492P/496P
520A

SERVICETEKNOTES

TABLE OF CONTENTS

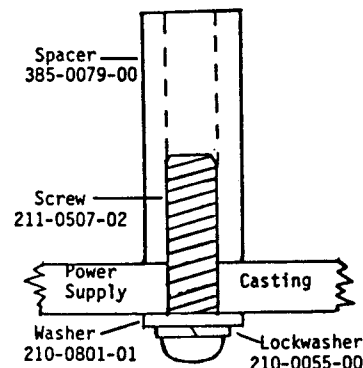
Some 49X instruments experience a change in sensitivity of about .2dB when the graticule lights are activated. This problem is the result of improper grounding for the Amp. Cal. and Log. Cal. pots on the front panel circuit board.

To eliminate this problem, the front panel circuit board, A38, must be changed. For instruments B010100 - B029999 use 050-1857-02. For instruments above B03XXXX, use 670-7050-03.

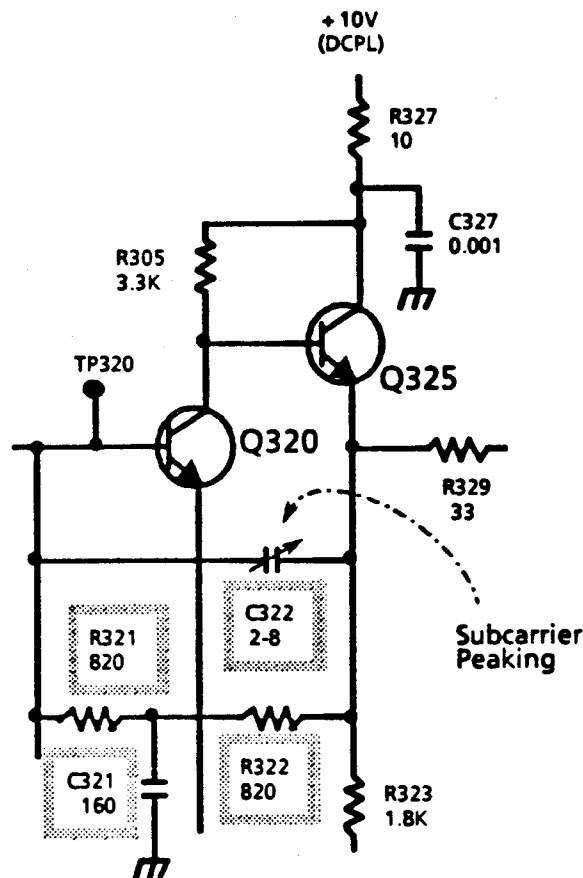
- B. Terminate the RF Input with a 50 ohm termination (BNC-to-N adaptor and BNC 50 ohm terminator). Turn the 496/P over to gain access to the RF deck. Remove the protective cover from the end of the variable load assembly (see Fig. 11A) and center the start spur potentiometer.
- C. Adjust the Frequency Control to center the zero-hertz response on screen.
- D. Insert a small "Jewelers" screwdriver into the access hole, on the diode assembly for the 1st mixer, and adjust for minimum amplitude of the zero-hertz response.

Use extreme care when adjusting the screw clockwise so as not to crack the internal diode substrate due to excessive torque. The end of the range is easily recognized when the screw bottoms out.

- E. Re-adjust the start spur potentiometer in the variable load assembly (see Fig. 11A) for a -20 dBm or less zero-hertz response amplitude.
- F. Replace the protective cover over the adjustment for the variable load assembly.

Figure 1.

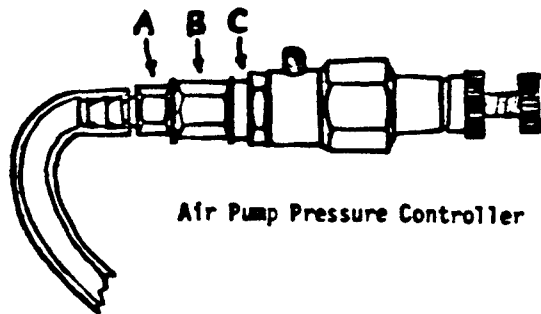
Paragraph 5 of the 4691 "Auto Purge" Modification Installation Guide makes a point of warning against changing the thumbscrew setting of the pressure valve. It should have also mentioned the fact that rotating the relief air outlet fitting will also effect the pressure setting. This is very easy to do when tightening the newly installed adapter part "A" supplied with the kit.

When installing adapter part "A" on the air pump pressure controller, part "B" should be held with a wrench while tightening part "A". This is done to prevent part "C" from being disturbed and subsequently changing the air pressure.

4691 VACUUM PAPER CARRIER

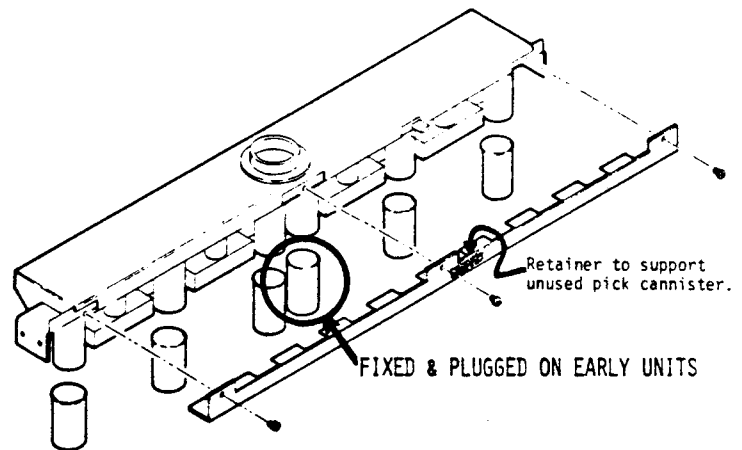
Earlier version 4691s that were upgraded in the field may contain a manufacturing flaw. The earlier version 4691 has the right middle suction cannister (facing copier from the paper exit) fixed and plugged. The retainer for all the suction cannisters, should have a small rectangular piece of metal glued to the inside of said retainer assembly, such that it fixes the unused suction cannister up-and-out-of-the-way.

Some of the retainer assemblies that arrived in the field have the small rectangular piece of metal glued to the retainer, such that it fixes up the left center suction cannister instead of the right center suction cannister. This will cause problems when picking paper and especially transparencies.

The situation can be remedied by prying off the small piece of metal with an exacto knife and regluing said piece in the correct position. Please remember to clean the surface of the retainer so that the small rectangular piece of metal will stick properly.

Figure 1
118-3036-00 Assembly

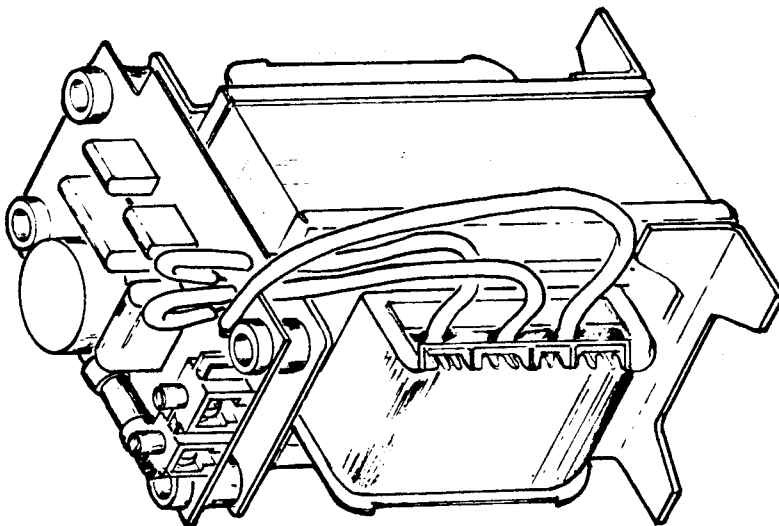
The 220/240 volt versions of the 4695 use an internal 2:1 stepdown transformer to lower the line voltage to 110 volts. This transformer is part of an assembly (118-3036-00) which contains a circuit board, mounting hardware and a small cable (see Figure 1). The cable carries the 110 volt output and plugs onto the power supply

board at the same location as the power cord in a 110 volt product. The circuit board is represented in the System Interconnect Schematic in the service manual (please refer to the May 1984 version of the manual for the corrected schematic). The only field replaceable component on the circuit board is an 0.8 ampere fuse (P/N 159-0234-00). The transformer assembly as shipped, requires that leads from the winding taps be soldered to select either 220 or 240 volt mains. The manner of connection is self-evident by the silk screening on the circuit board.
